**CONSTRUCTION BULLETIN
No. 002**

**Institution: California Institution for Men (CIM)
Project Name: Replace Roofs Phase 1
Construction Bulletin Number: 002
Date of Issuance: February 6, 2026**

Description: This Bulletin makes modifications and corrections to the Project Manual and Drawings as described below.

DATE: 11/03/2025
SHEET NUMBER
A3.11
27 OF 80 SHEETS V1

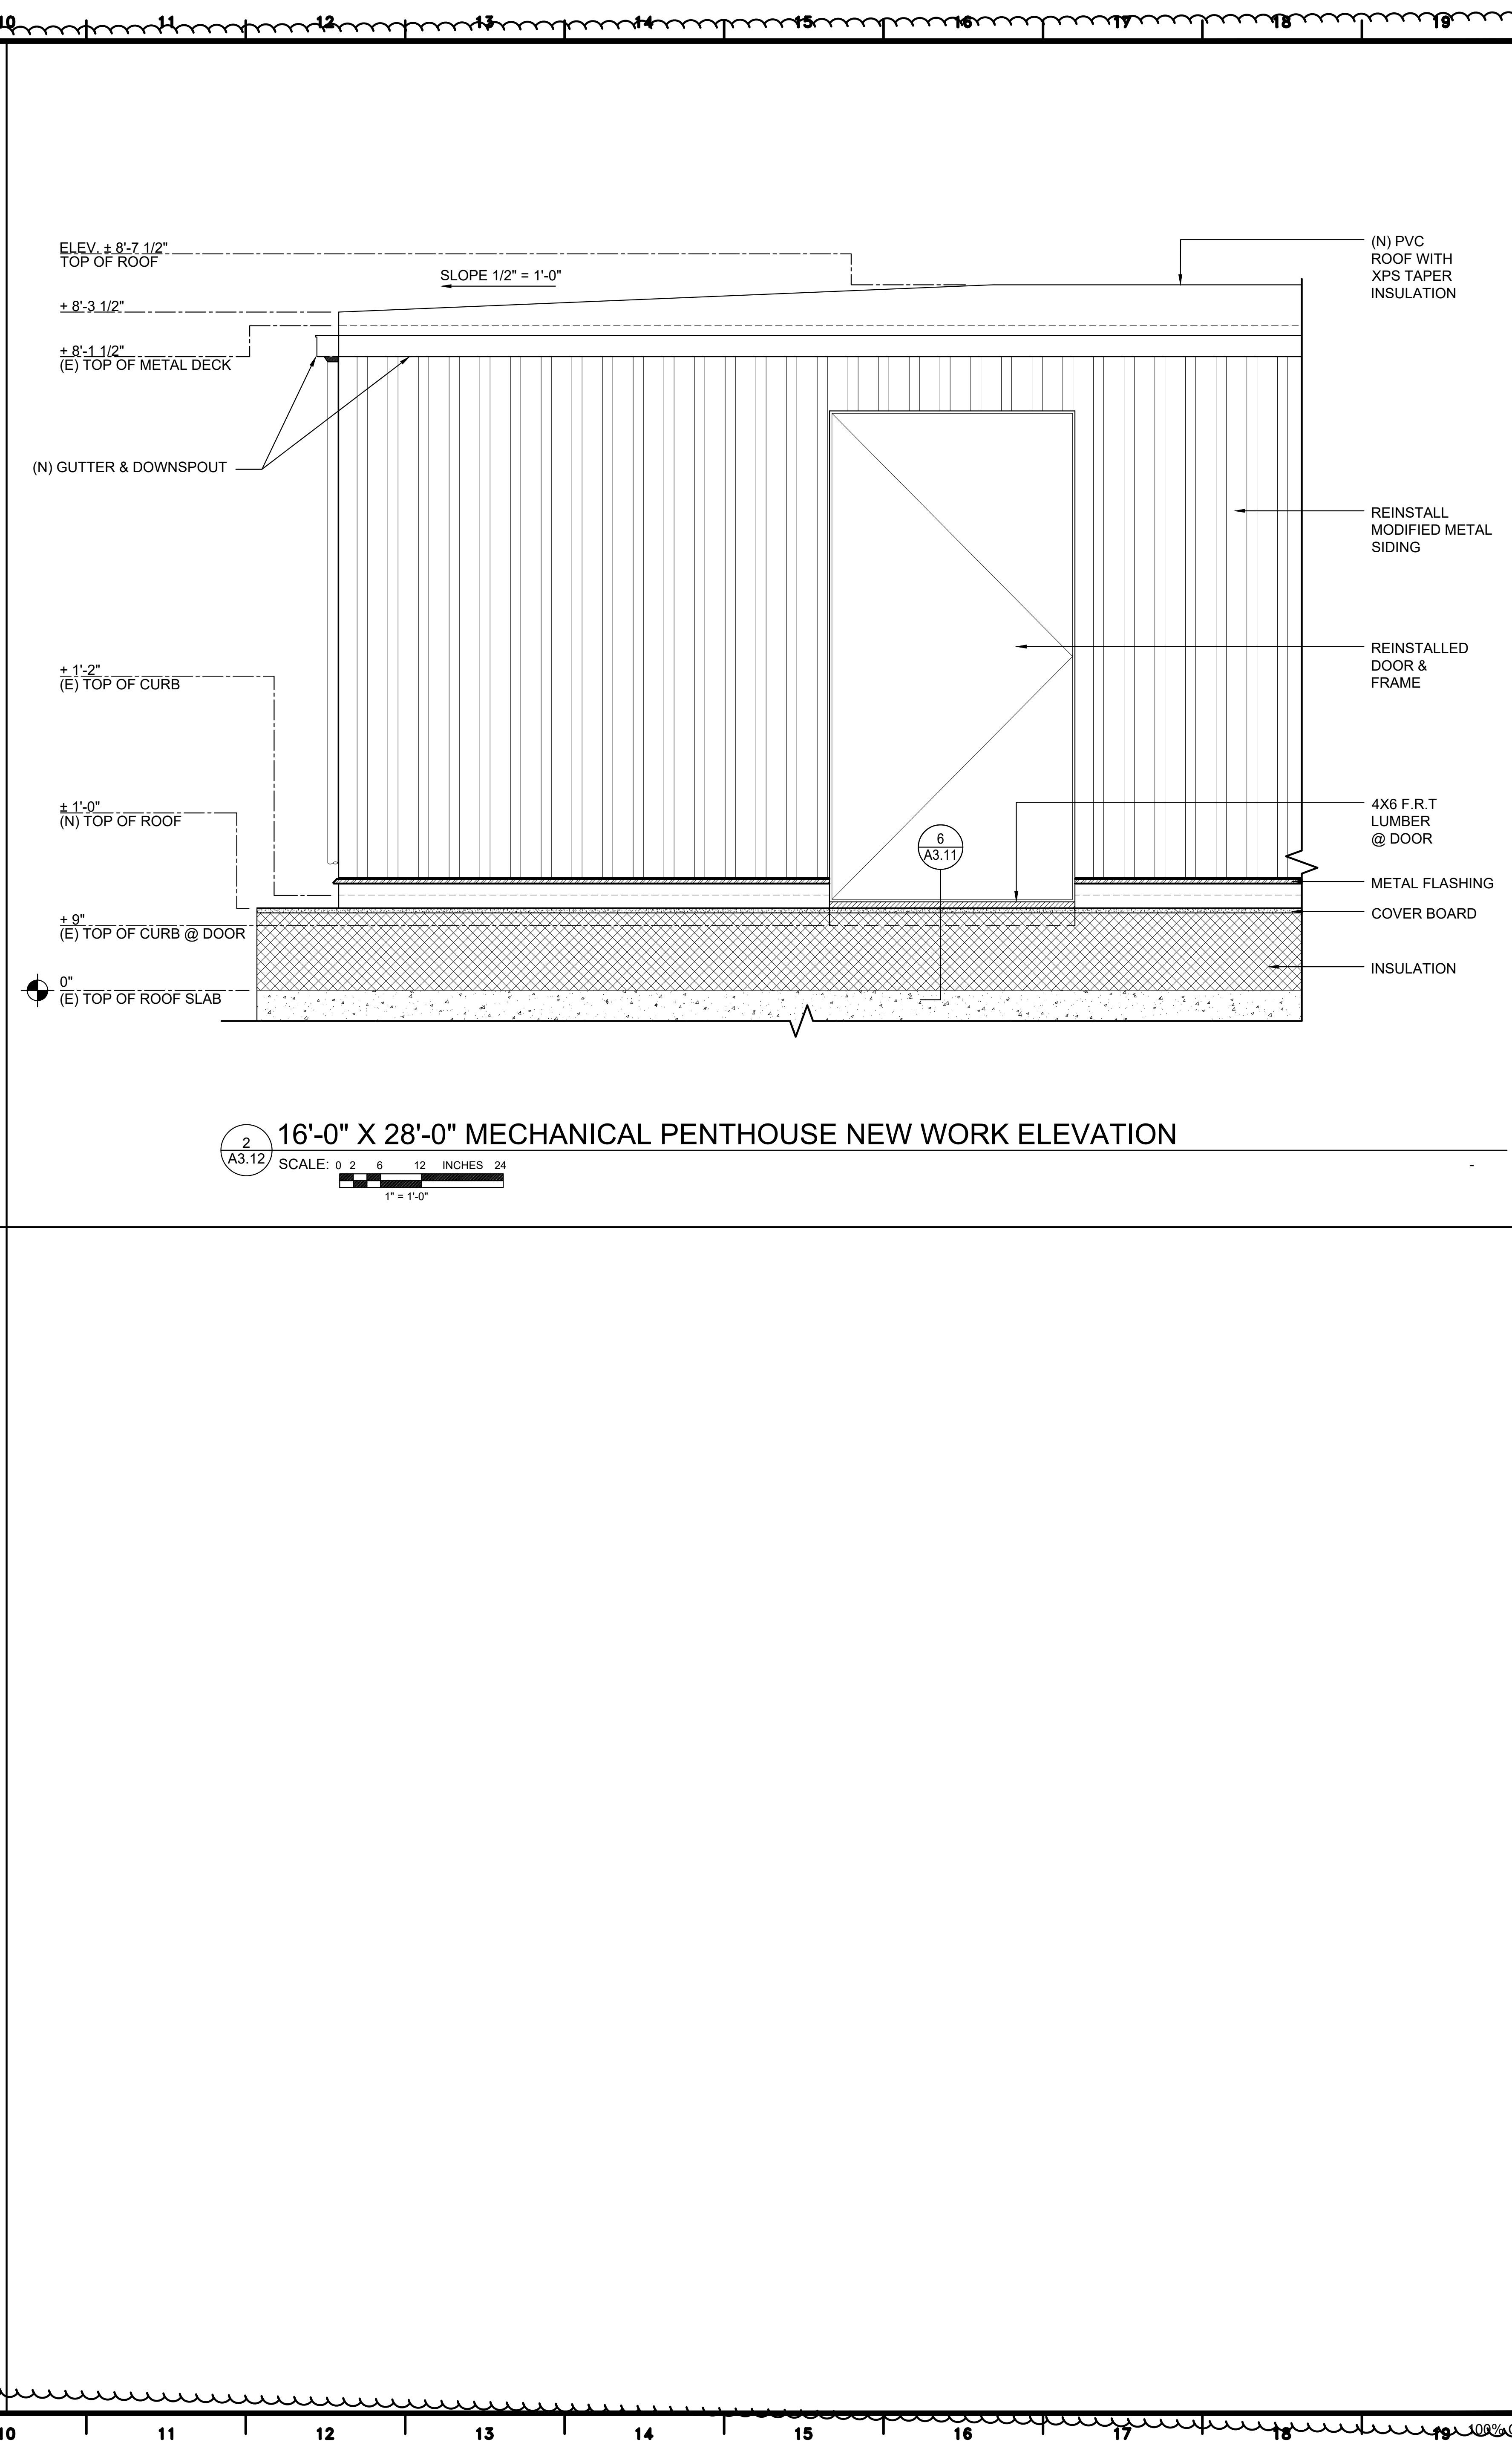
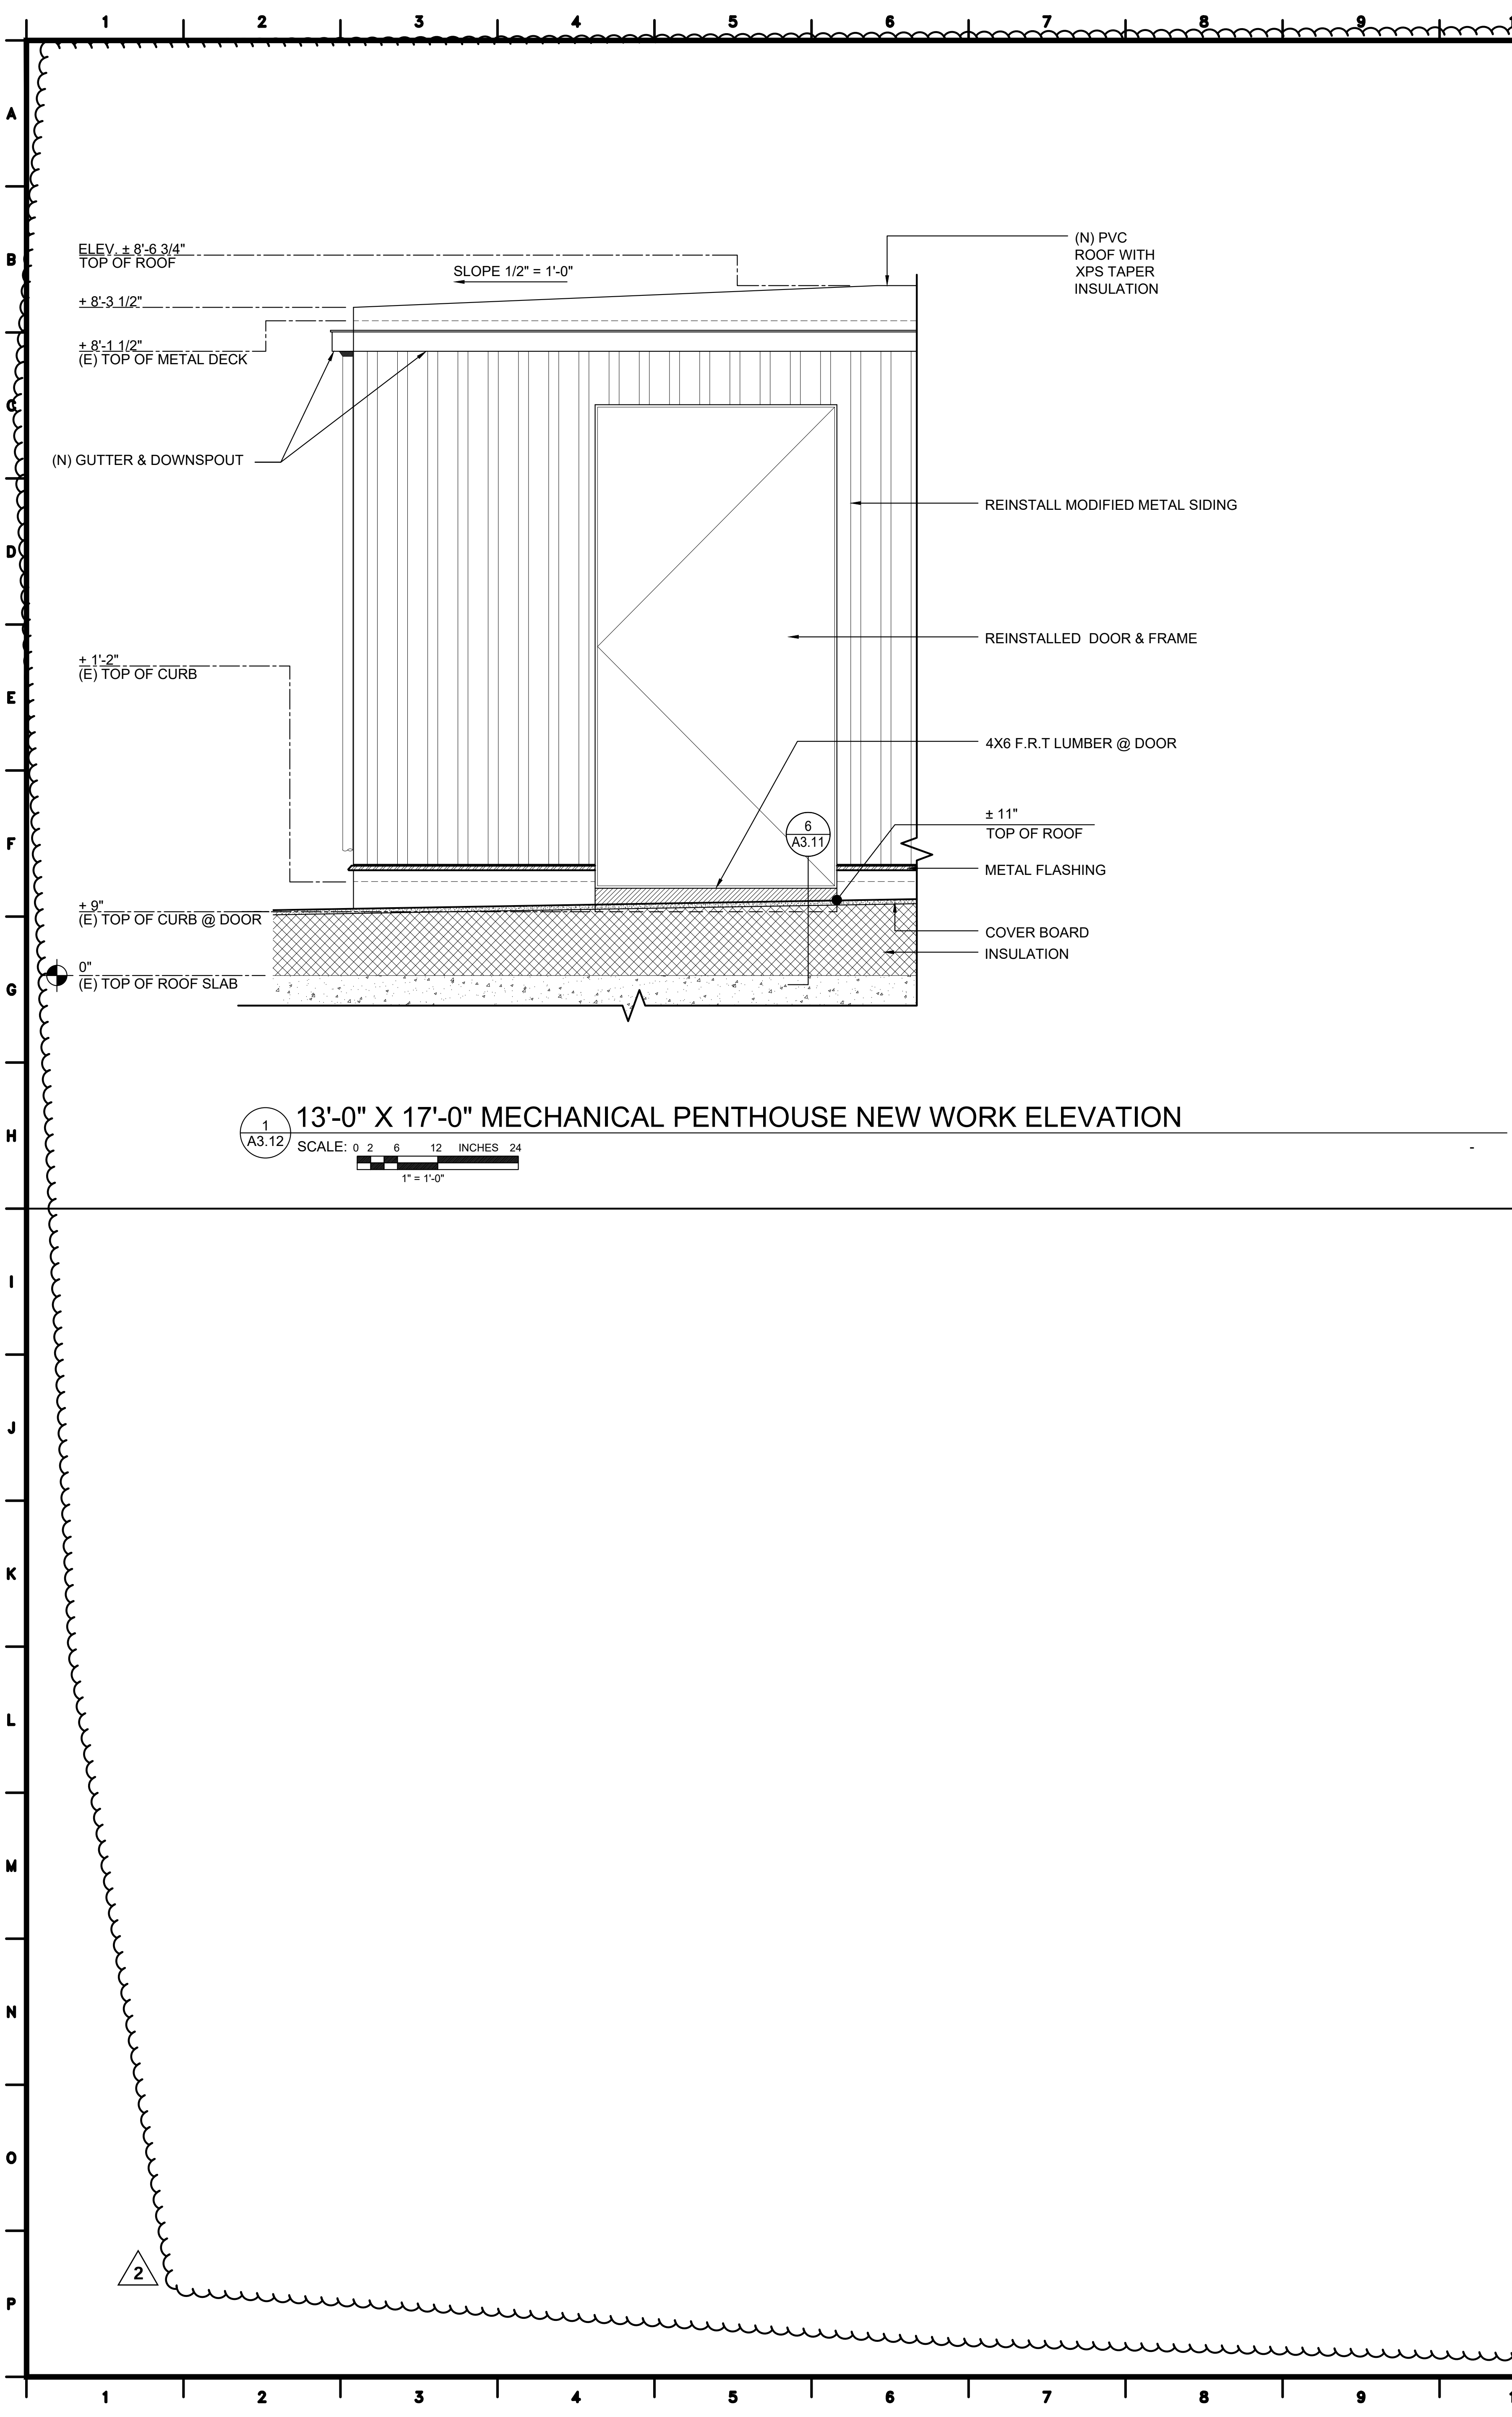
14. **Add** new Sheet **A3.11 – MECHANICAL PENTHOUSE DETAILS**
